ADDENDUM NO. 1

Carmel High School Football Scoreboard
2440 Smoky Row Road
Carmel, IN 46032

Carmel High School Football Scoreboards

Project No. 224213.00

E3.01

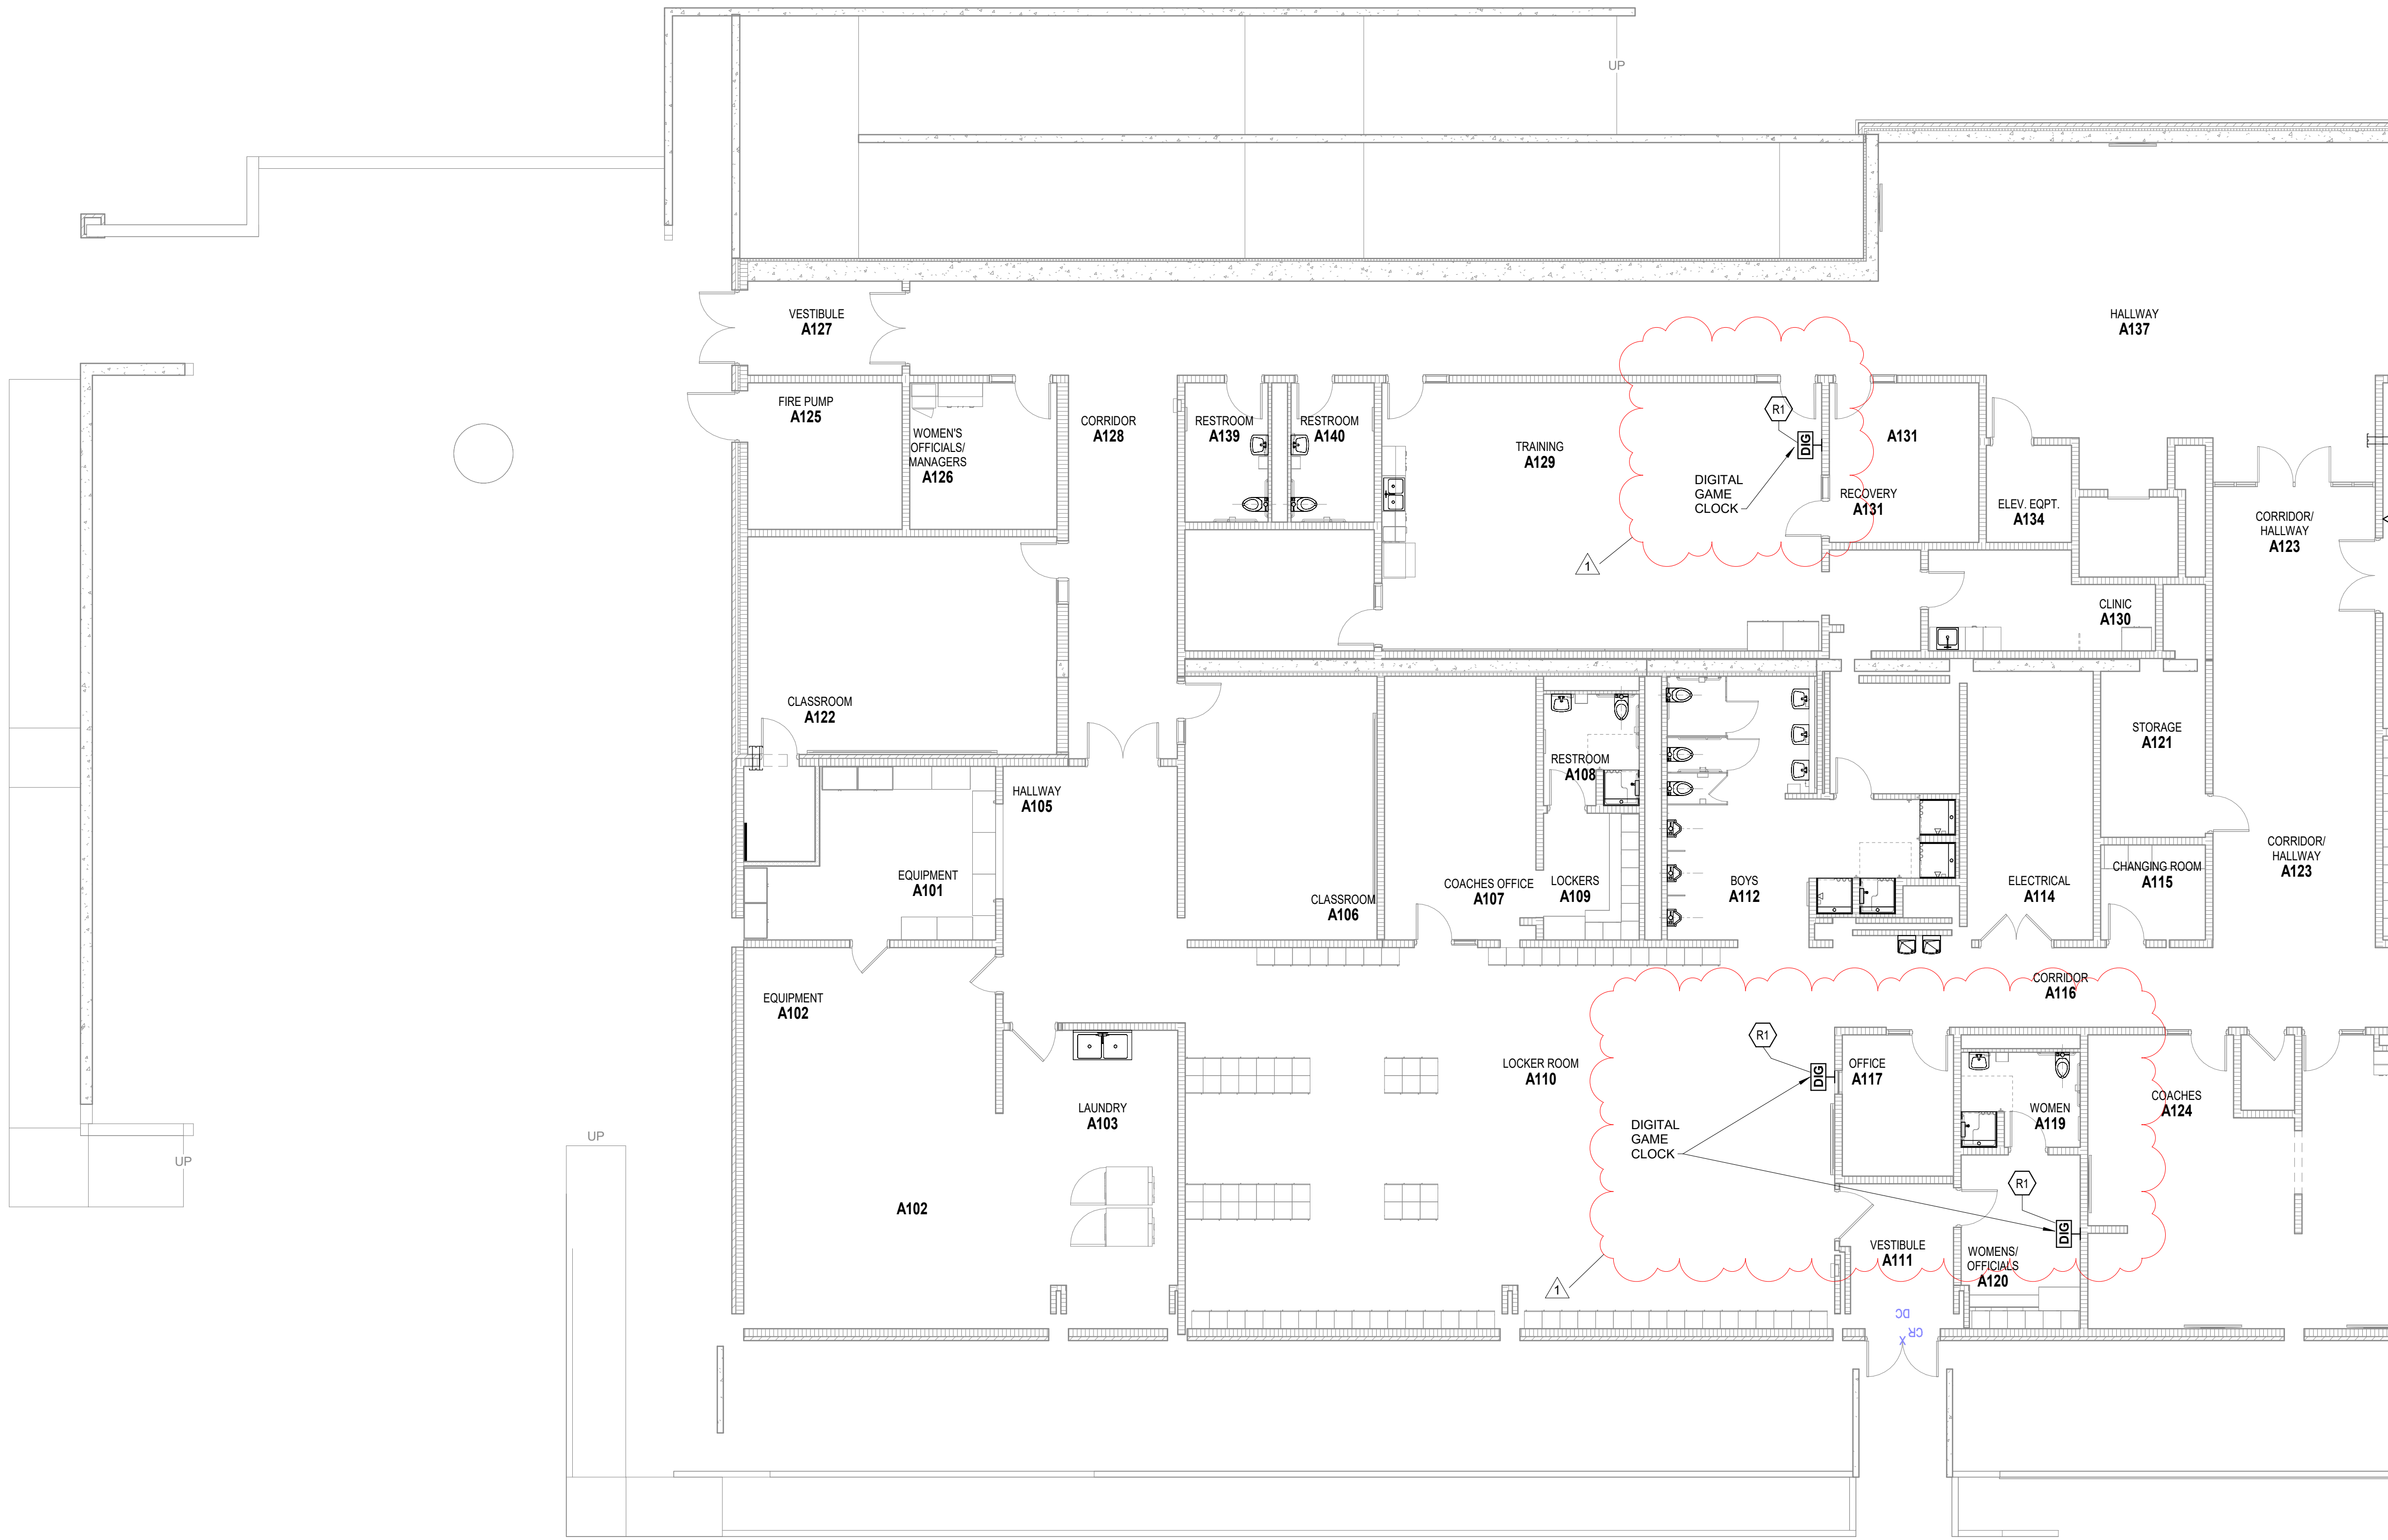
- R1 DAKTRONICS TI-2031 GAME CLOCK. PROVIDE ONE PAIR BELDEN 8751 22 AWG SHIELDED CABLE INTO 1" CONDUIT STUBBED UP INTO PRESSBOX 4403 CONNECTING TO THE DAKTRONICS CONTROLLER. THE 120 VOLT POWER IS TO BE FED FROM THE NEAREST DUPLEX RECEPTACLE CIRCUIT.

E3.02

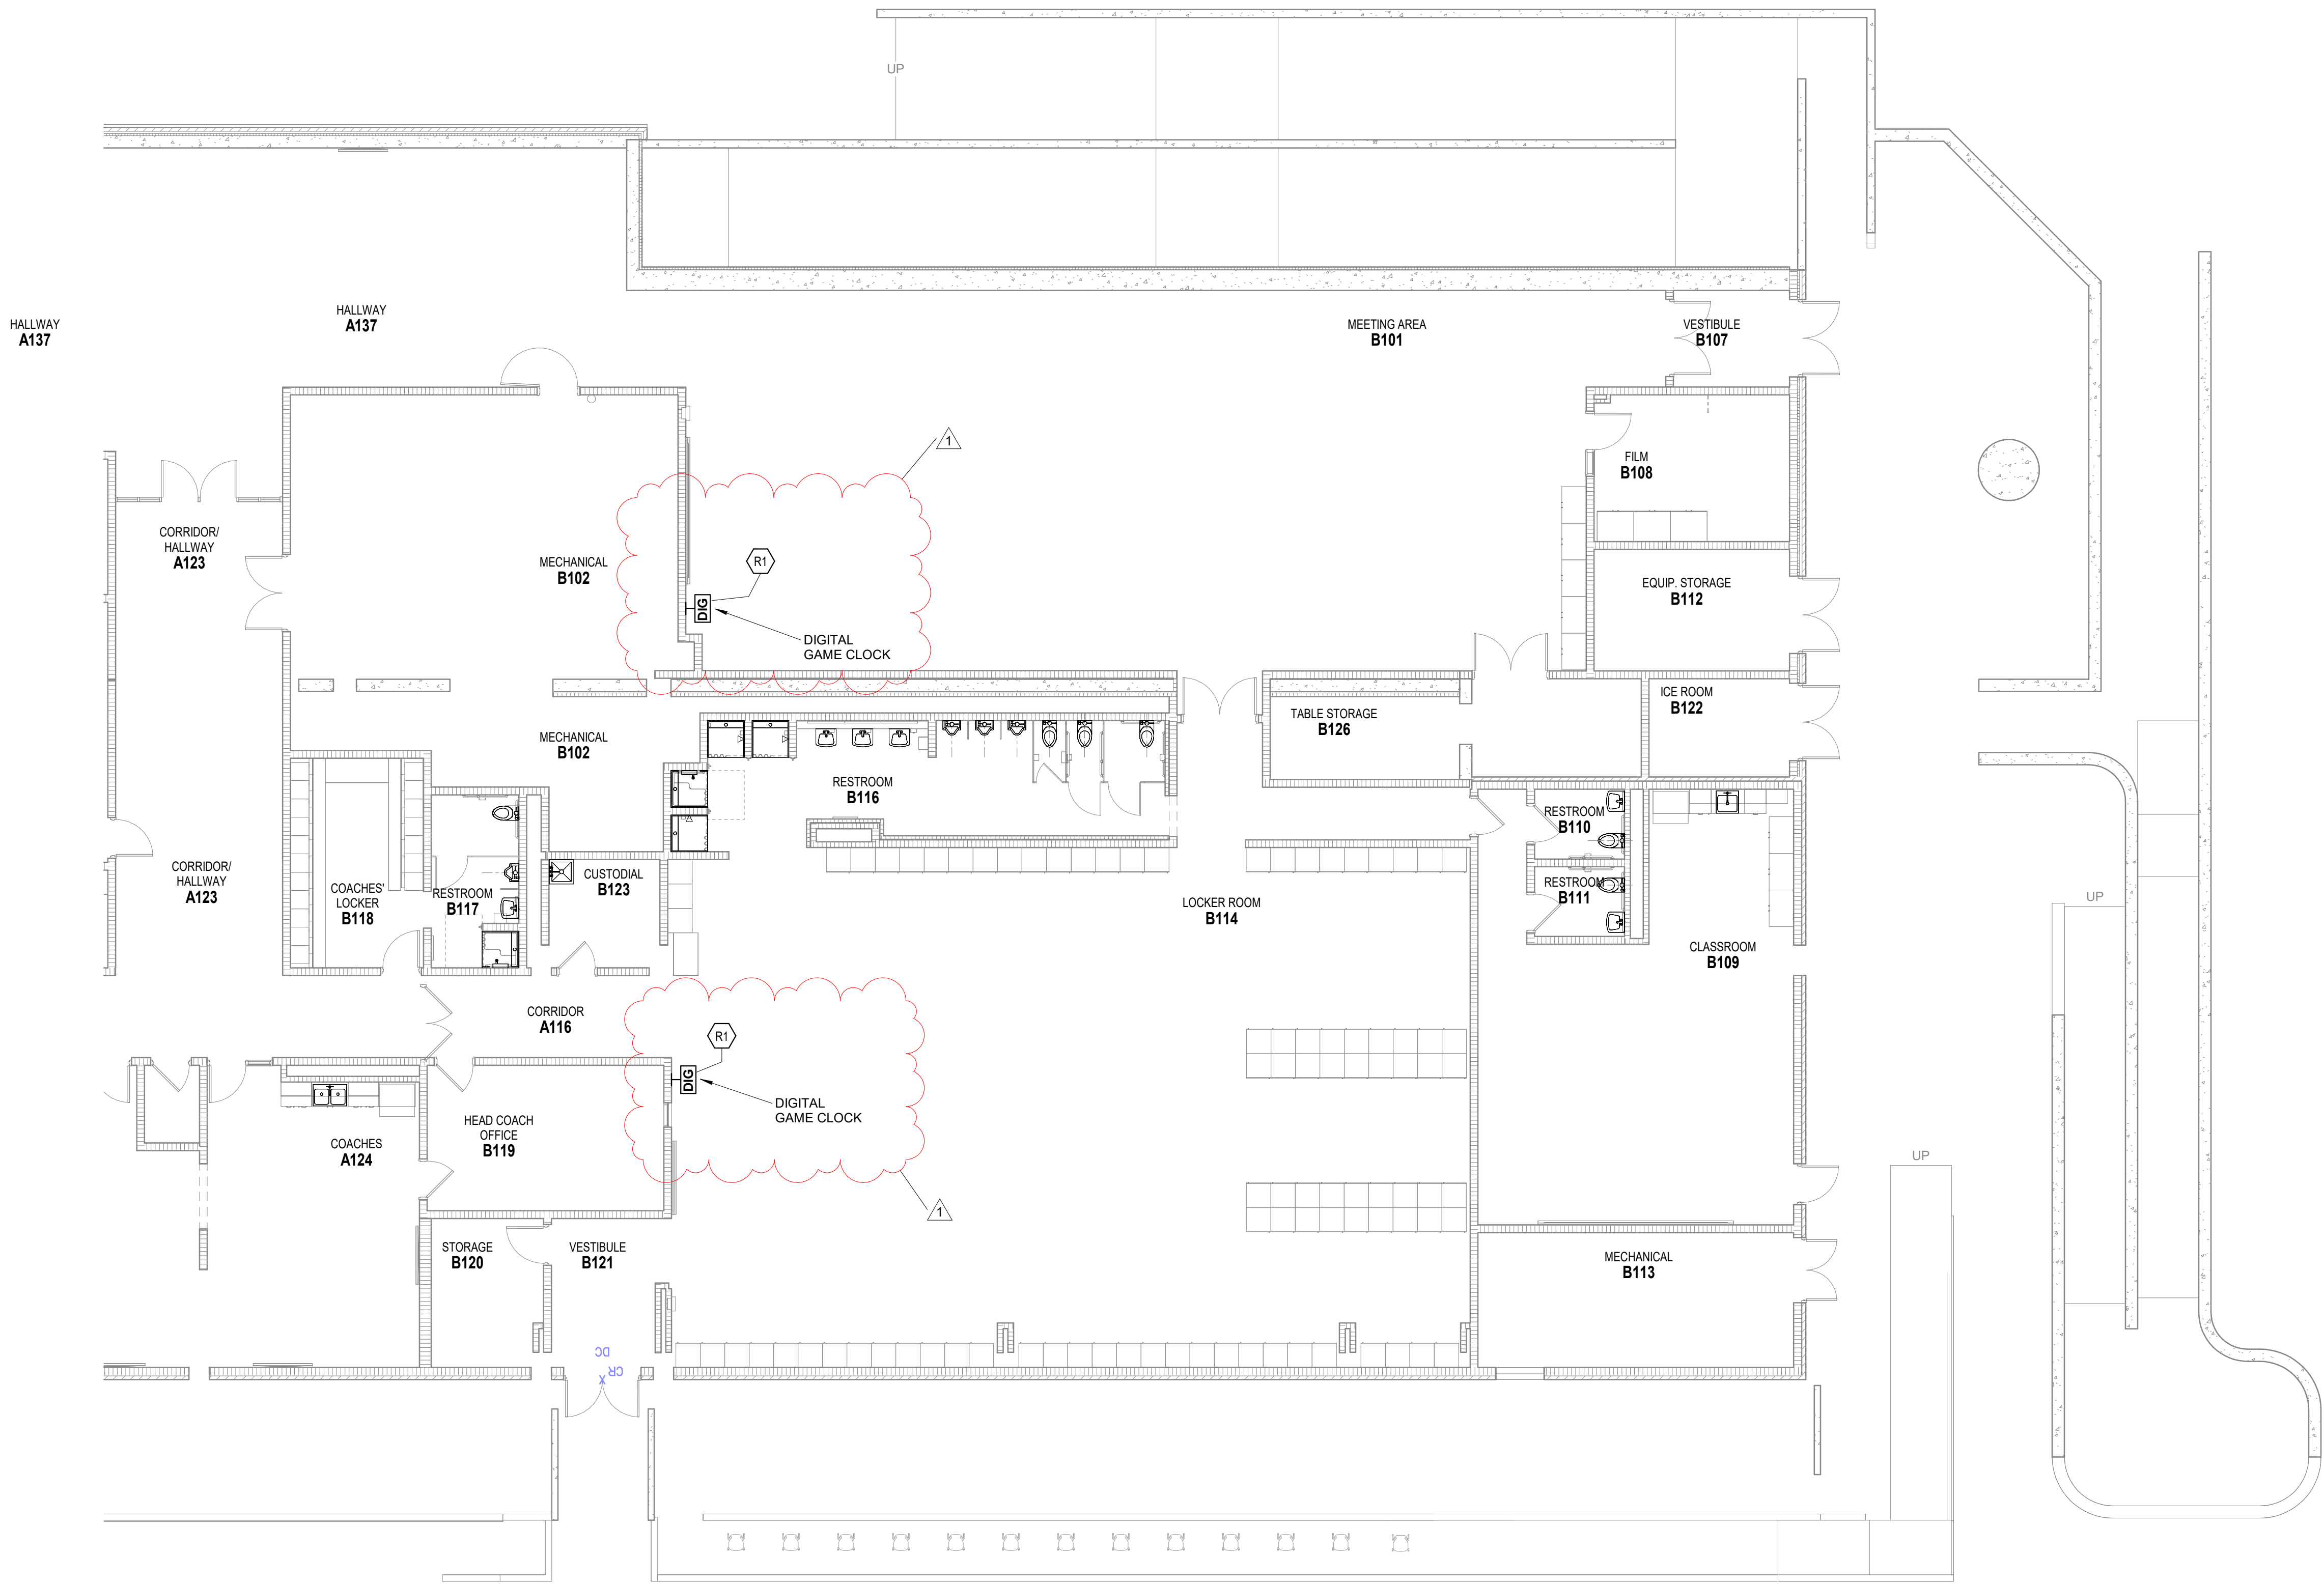
R1 DAKTRONICS TI-2031 GAME CLOCK.
PROVIDE ONE PAIR BELDEN 8761 22
AWG SHIELDED CABLE INTO 1" CONDUIT
STUBBED UP INTO PRESSBOX 440B
CONNECTING TO THE DAKTRONCS
CONTROLLER. THE 120 VOLT POWER IS
TO BE FED FROM THE NEAREST
DUPLEX RECEPTACLE CIRCUIT.

T3.01

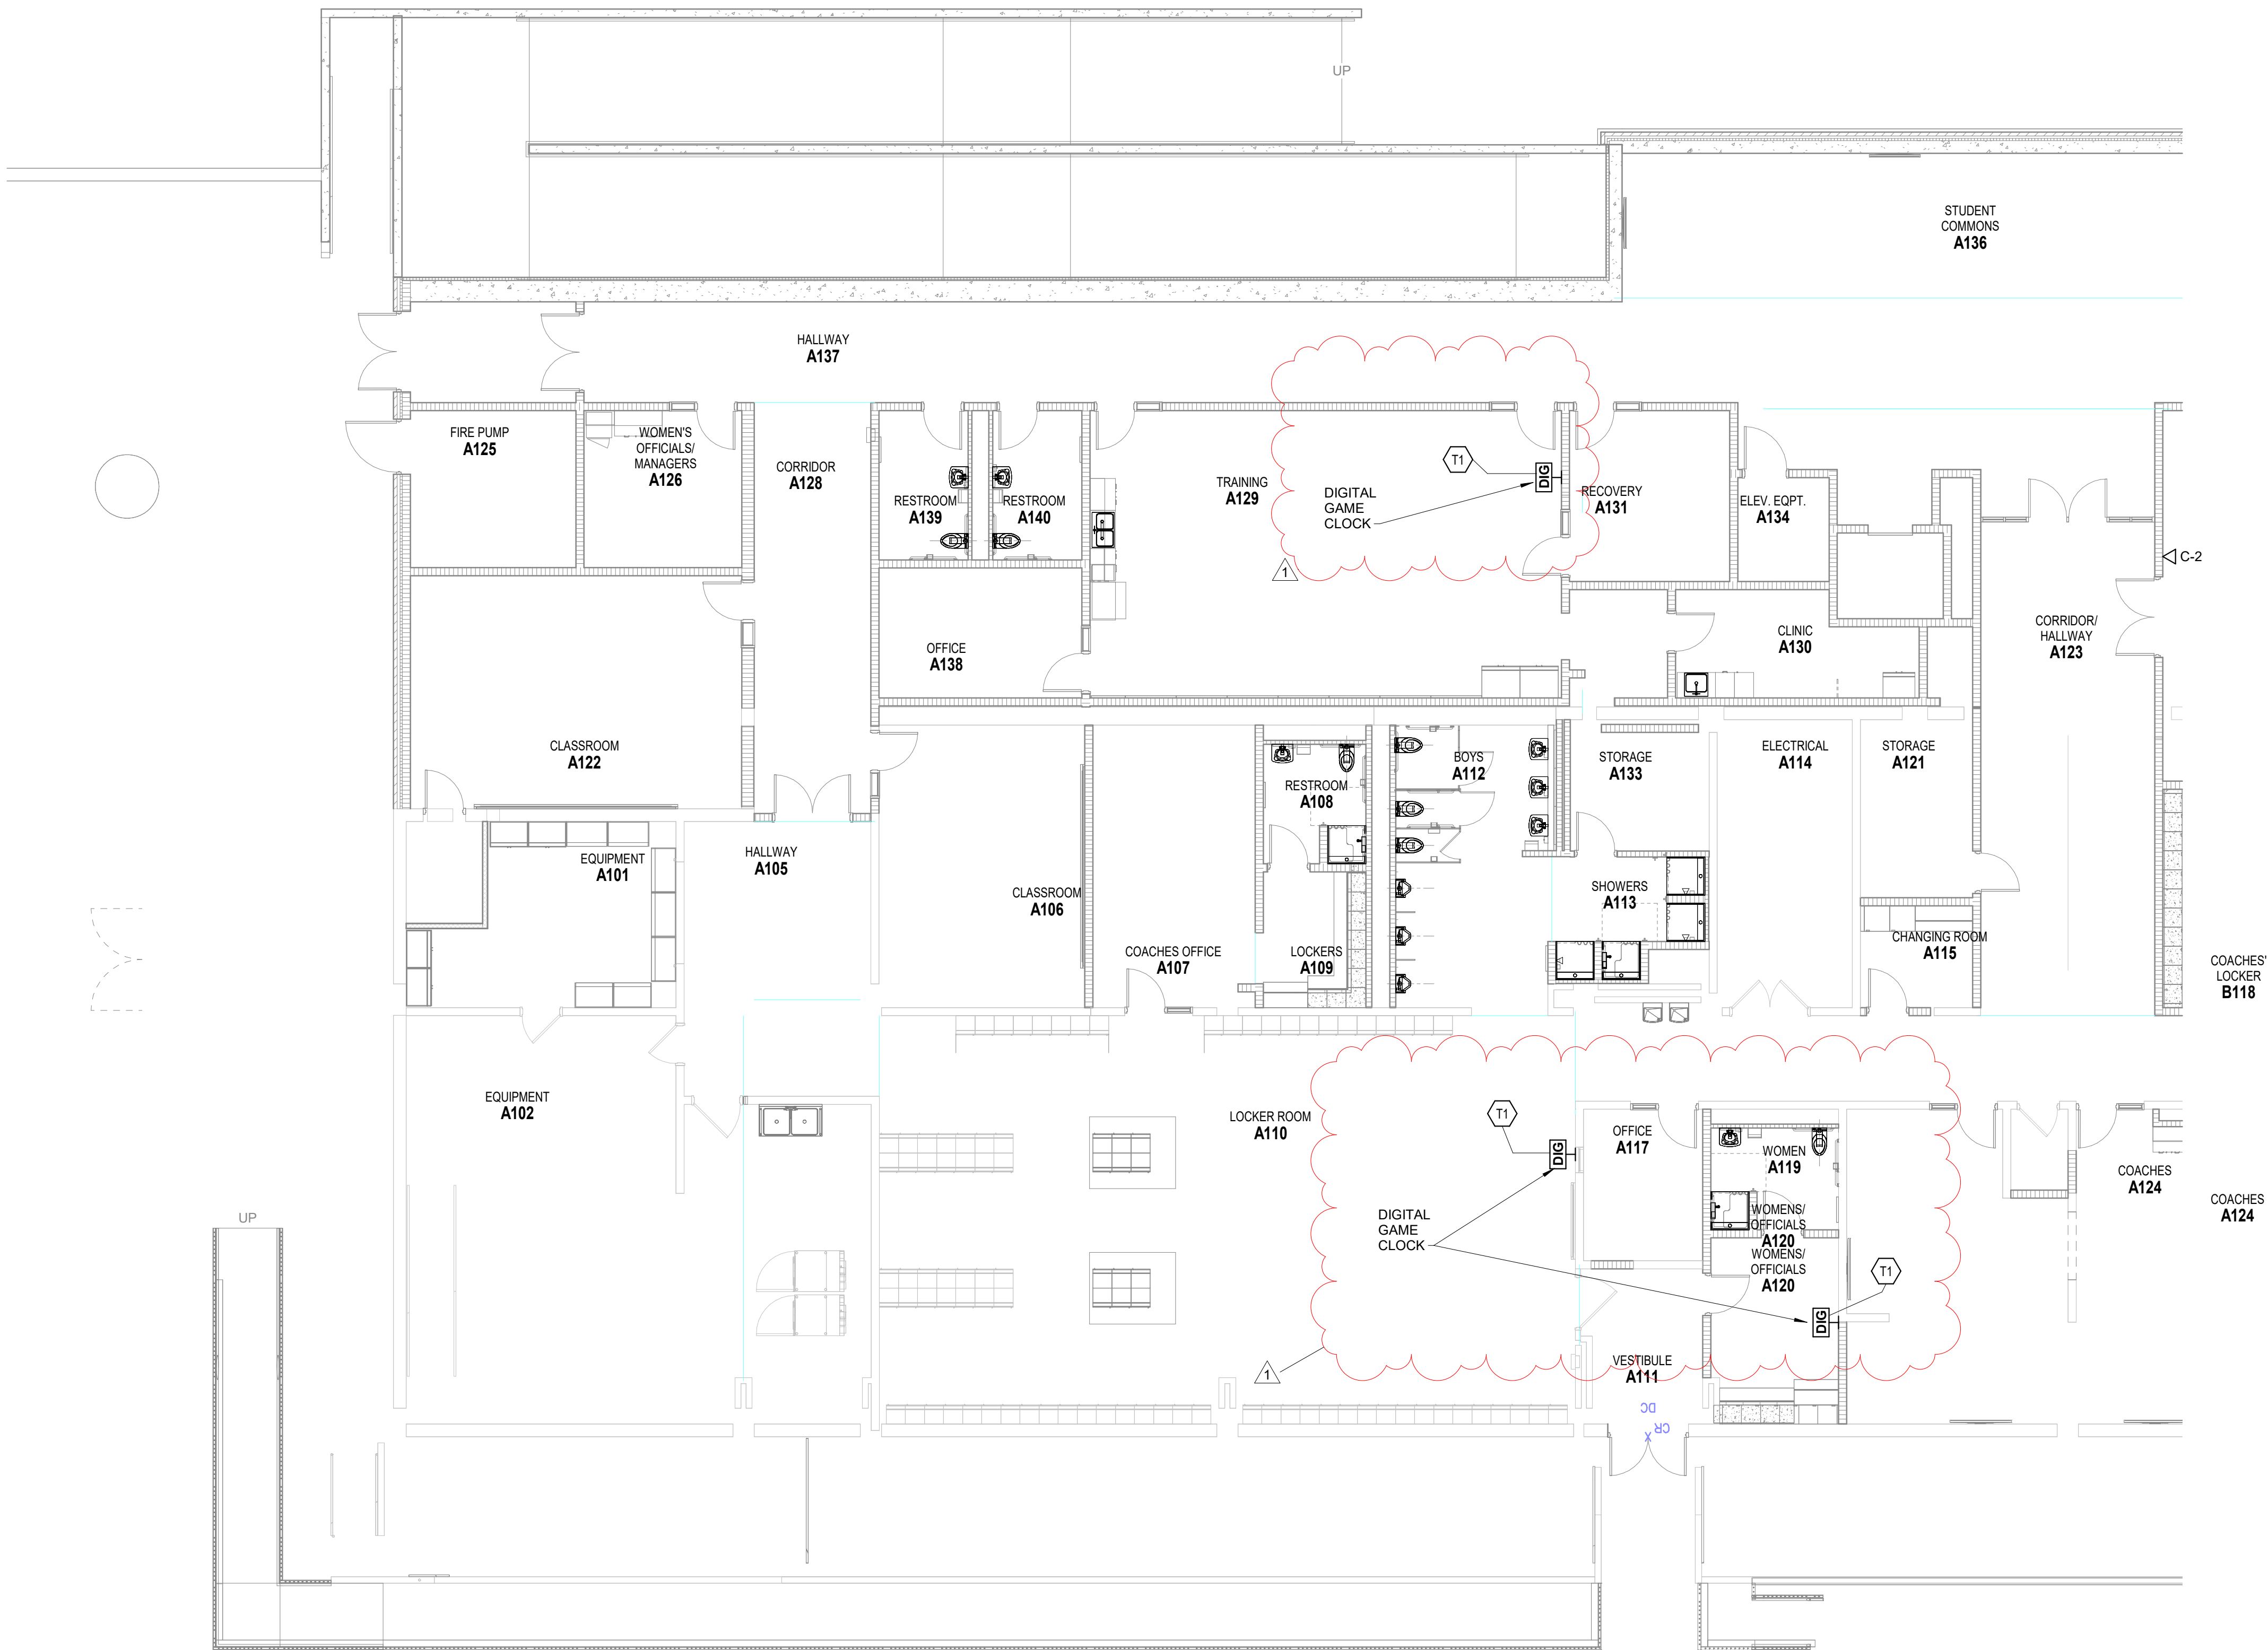
T1 DAKTRONICS TI-2031 GAME CLOCK. THE 120 VOLT POWER IS TO BE FED FROM THE NEAREST DUPLEX RECEPTACLE CIRCUIT.
